Access Compliance Report Public Rights-of-Way (Curb Ramps)

Main Street: **NARROW_CANYON_RD** Cross Street: **AURA_LN** Location: **NE**

ADA ID: **RPRK211028125912** Ramp Type: **Type 4 - Parallel** Initial Pass/Fail: **Fail** Overall Compliance: **No** Severity Score: **2**

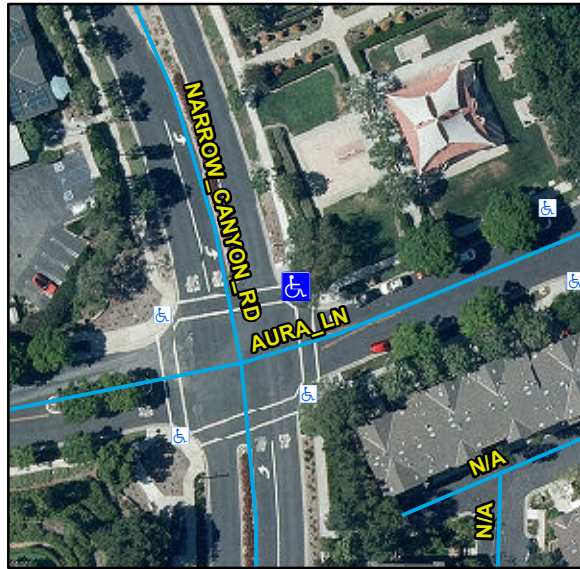
Compliance	Description	Data	Compliance	Description	Data
N/A	Ramp Length LT (in)	123	N/A	Ramp Length RT (in)	138
Yes	Ramp Width LT (in)	87	Yes	Ramp Width RT (in)	88
Yes	Ramp Run Slope LT (%)	6.9	Yes	Ramp Run Slope RT (%)	3.3
No	Ramp Cross Slope LT (%)	2.1	No	Ramp Cross Slope RT (%)	4.4
N/A	Landing Present	N/A	N/A	DWS Provided	N/A
N/A	Landing Length (in)	N/A	N/A	DWS Contrast	N/A
N/A	Landing Width (in)	N/A	N/A	DWS Length (in)	N/A
N/A	Landing Run Slope (%)	N/A	N/A	DWS Full Width	N/A
N/A	Landing Cross Slope (%)	N/A		DWS Offset Type	N/A
N/A	Landing Movement Obstructed?	N/A	N/A	DWS Offset Left (in)	N/A
	Landing Movement Type	N/A	N/A	DWS Offset Right (in)	N/A
N/A	Landing Shared	N/A			
N/A	Clear Space	Yes			
N/A	Clear Space To Crosswalk (in)	48			
N/A	Marked Crosswalk 1	Yes	N/A	Marked Crosswalk 2	Yes
	Crossing 1 Direction	W		Crossing 2 Direction	S
	Marked Crosswalk 1 Width (in)	144		Marked Crosswalk 2 Width (in)	144

Remove & Replace Curb Ramp With Two New Directional Ramps or Equivalent.
